LAVENTURE & ZEISS ENGINEERING, INC.

April 29, 2016

RE: Drawdy Concrete Construction
2551 Peters Road

**Re: Technical Review – Drawdy Concrete –
2551 Peters Road**

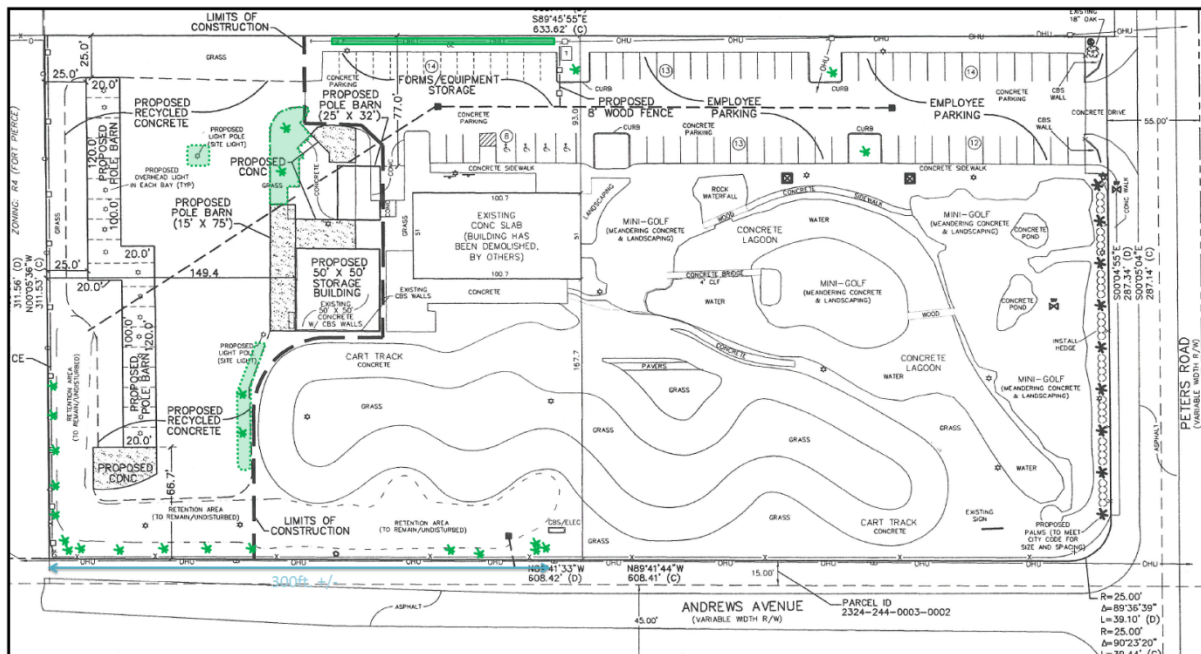
1) Pursuant to City Code Section Sec. 22-187 (4), (6), & (7), the proposed site plan shall include the installation of trees along the west and south property lines, adjacent to the retention area. Additionally, landscaping shall be integrated into the proposed vehicular use area and re-installed within the existing landscape islands within the parking area. The wood fence should be acceptable in-lieu of plantings/shrubs. Screening is encouraged for the forms/equipment storage.

A conceptual mark-up and the applicable code requirements are presented below for guidance:

RESPONSE: Comments noted and plans revised to reflect comments.
